## **Central Planning Authority**

**Agenda** for a meeting of the Central Planning Authority to be held on April 28, 2021 at **10:00am, in Conference Room 1038, 1<sup>st</sup> Floor, Government Administration Building, Elgin Avenue.**

**CPA/09/21**

*Figure 4: Extract of submitted plans overlaid on LIS 2018 aerial imagery showing the proximity of the split/fissure to the western proposed dwelling (Source: Declan O'Brien Architectural Services & Cayman Land Info)*

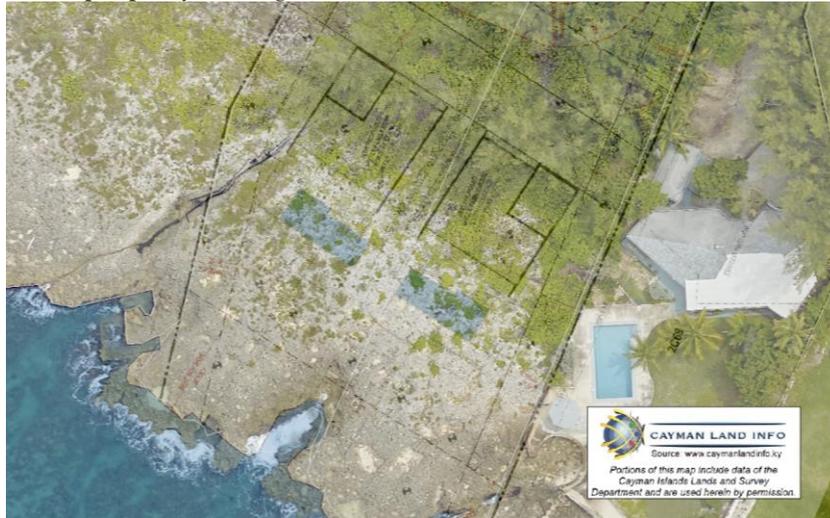
*The western single family home is extremely close to the ironshore split/fissure, and the DoE will not support any future filling of or works to the split as it is directly connected to the sea and Marine Park. The DoE would urge the applicant to seek advice from a structural engineer to ensure that the split/fissure does not cause a threat to the structural integrity of the property. The home could also be impacted as the split/fissure is directly connected the sea, and could potentially bring storm waves closer to the property during inclement weather.*

Figure 2: Application site plan & October 2020 MHWM survey geo-referenced on to 2018 aerial imagery

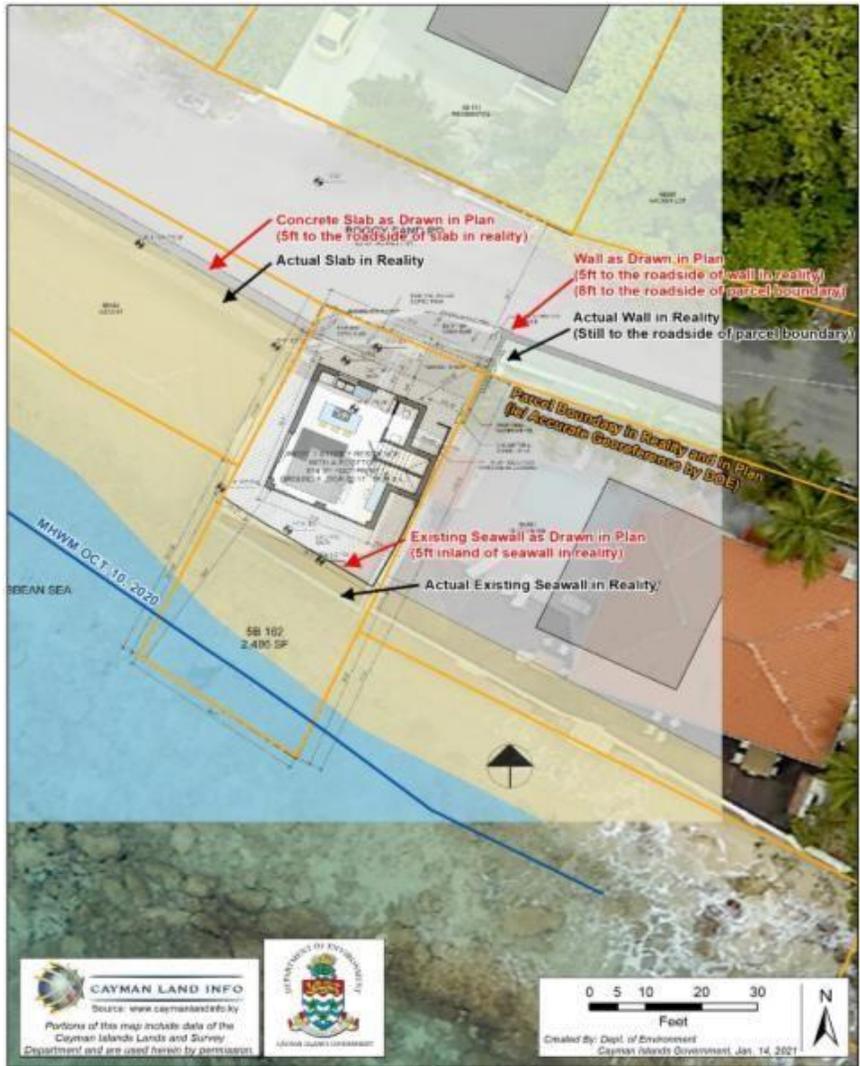
*In order to assess the application, we attempted to overlay the site plans on aerial photography. However, the dimensions stated on the site plans appear to be inaccurate.*

*The DoE's georeferenced plans show that the Mean High Water Mark surveyed on 10 October 2020 is much closer to the development than Site Plan Sheet A101 shows, and that the existing seawall is also closer to the sea than the application plan shows. Our georeferencing results in a setback of only 21 feet from the 10 October 2020 Mean High Water Mark survey (see Figure 2). The Development and Planning Regulations (2020 Revision) Section 6(4) states that the site plan must show the location of the proposed building, the location of existing buildings on the site and on adjacent land, the front, and the rear and side setbacks. It should be a given that these dimensions must also be accurate.*

In addition, as shown in Figure 2, both the georeferenced plans and the Applicant’s Site Plan Sheet A101 show that parts of the existing development are located within the public roadway, and that the site is unable to accommodate the single proposed parking space for the development. The plans show that the proposed parking space is located in the public roadway of Boggy Sand Road rather than within the Applicant’s site.

Figure 3: An extract of the Plan over the LIS 2018 aerial image, with the Central Mangrove Wetland boundary (orange red line).

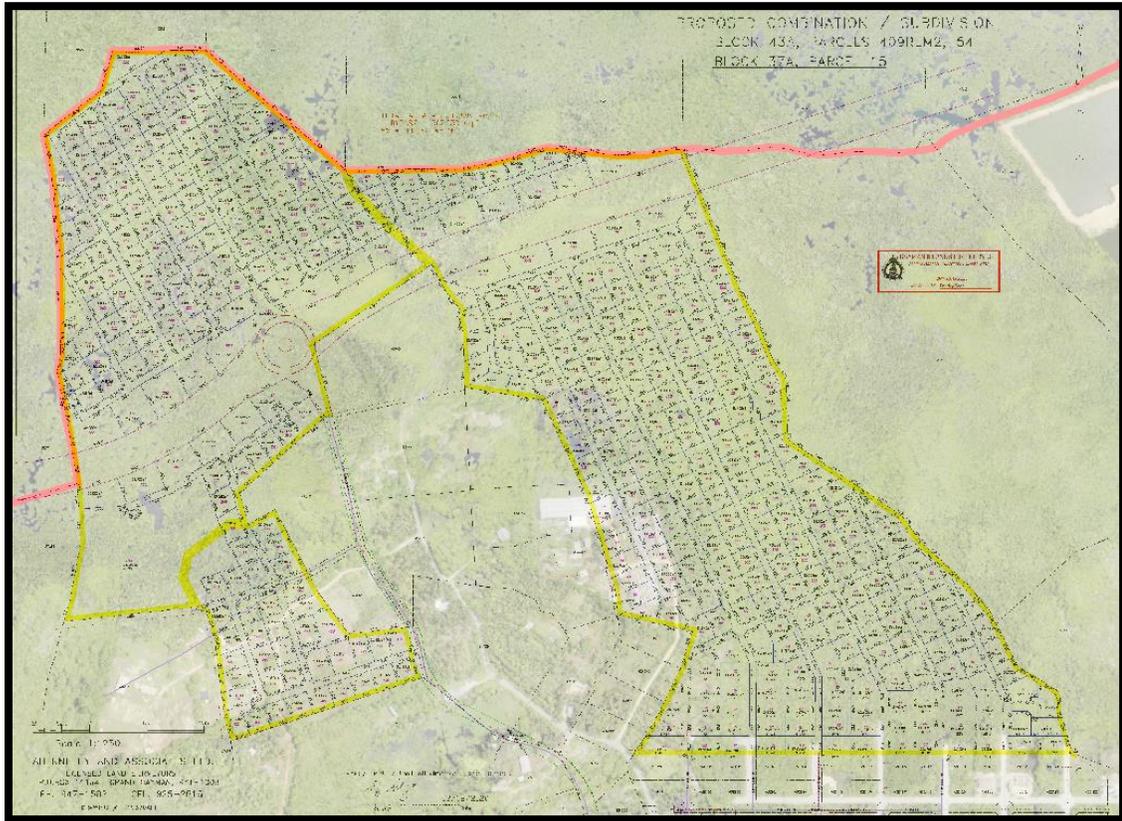
*The Development Plan is severely outdated. It does not reflect accurately how the island should be developed moving forward taking into consideration the population size, projected population growth, the environment and climate change. Therefore, without an updated development plan for the islands, there is no vision on how the island should progress in terms of development. This can result in unnecessary fragmentation of pristine habitats and loss of valuable limited resources (such as land and associated ecosystem services). It is recommended that prior to approval of this subdivision, the*

supply and demand of residential lots should be determined. The current Lookout Gardens Subdivision is approximately 40% built out, which raises the question of the need for the proposed subdivision development when more than 50% of the existing subdivision remains undeveloped and within the ownership of the original developer.

*Figure1: Aerial imagery showing the proposed seawall and buildings (Source: LIS 2018)*

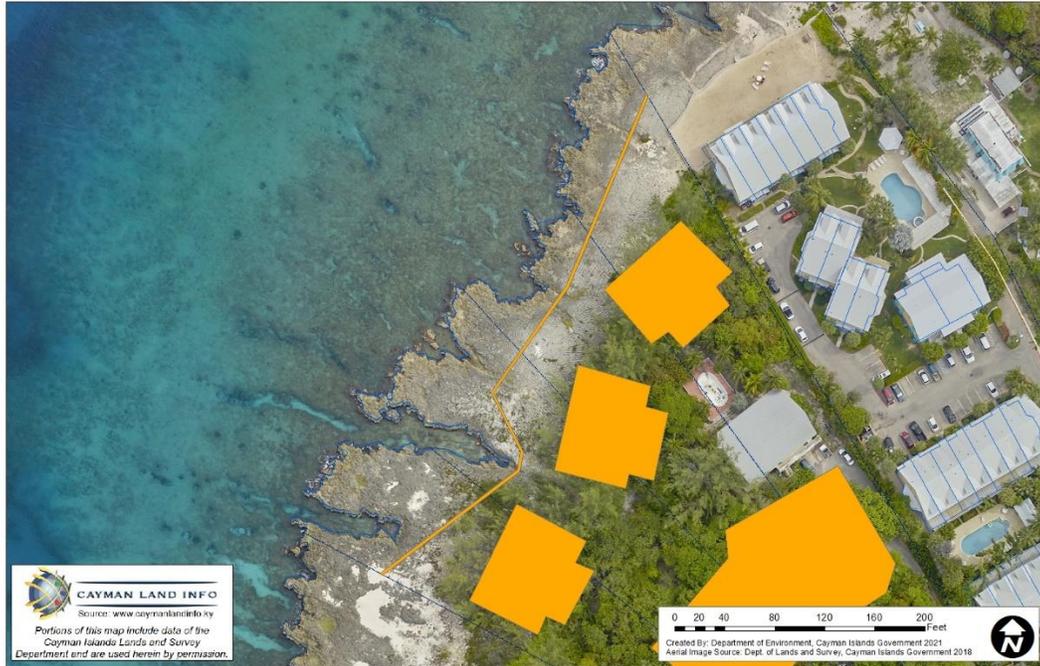
*The Department notes that the proposed development does not meet the required coastal setbacks for an ironshore coastline, as set out in 8. (10) (c) of the Development and Planning Regulations (2021 Revision), particularly the proposed seawall which appears to only be set back from the nearest part of the surveyed MHWL line by 7ft 6in, as is shown in Figure 1 below. Similarly some apartment buildings are setback as little as 37ft.*

*Furthermore, we note that there are no design features, such as a wash through ground floor or positioning of the building on elevated pilings, to help mitigate against the effects of sea inundation on the proposed dwellings.*

Figure 2: Aerial Imagery showing the vegetation line on the coastline of the proposed development in 1994, 2004 and 2013 (Source LIS 2021.)

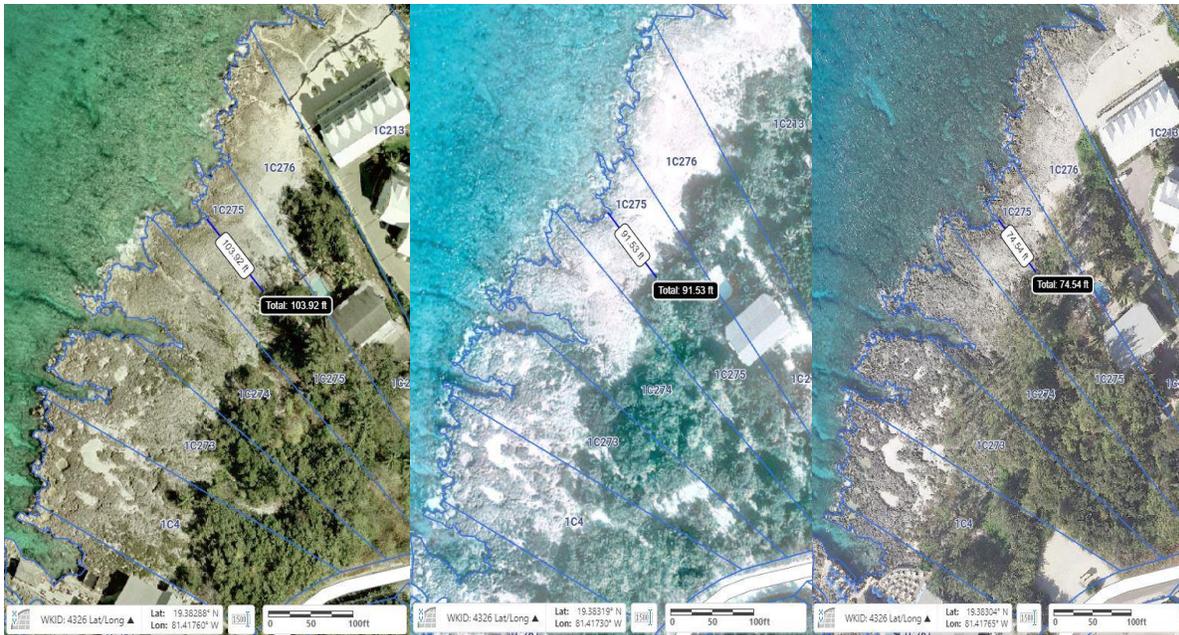
*The DOE does not support the granting of a variance in the coastal setback, based on the current design of the proposed development in this location. A review of historical aerial imagery shows that the vegetation line in this area has been setback at least 100-150ft from the MHWM over several decades, demonstrating the sea impact to the coastline (see figure2 below).*

*The Department of Environment would therefore recommend this application be refused and the setbacks increased, and/or design techniques be incorporated to make the development more resilient e.g. wash through or elevated structures. It is imperative that minimum coastal setbacks are met, particularly given climate change predictions for the region and the increasing prevalence of coastal erosion associated with inappropriately sited development, either on the active beach or too close to the Mean High Water Mark.*

## Fractures

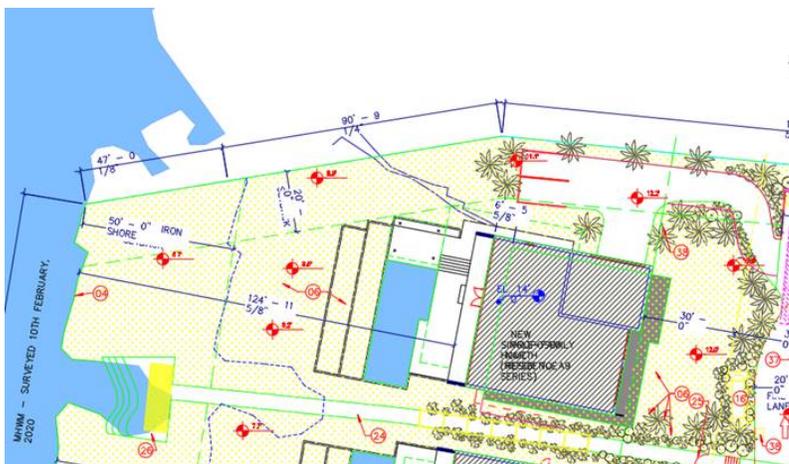
*"We dealt with the fracture within our geotechnical report. We conferred with the Dr Brian Jones, Emeritus Professor of Geology at the University of Alberta. Brian is the preeminent expert on the geology of the Cayman Islands. He is well known to the DoE. This commentary on fractures arises from our discussions with Brian.*

*"The fissure currently extends under the north wall of the north house only.....see site plan snippet and isometric markups below. [HOME HAS SINCE MOVED FURTHER FROM THIS FISSURE AS NOTED ABOVE]"*
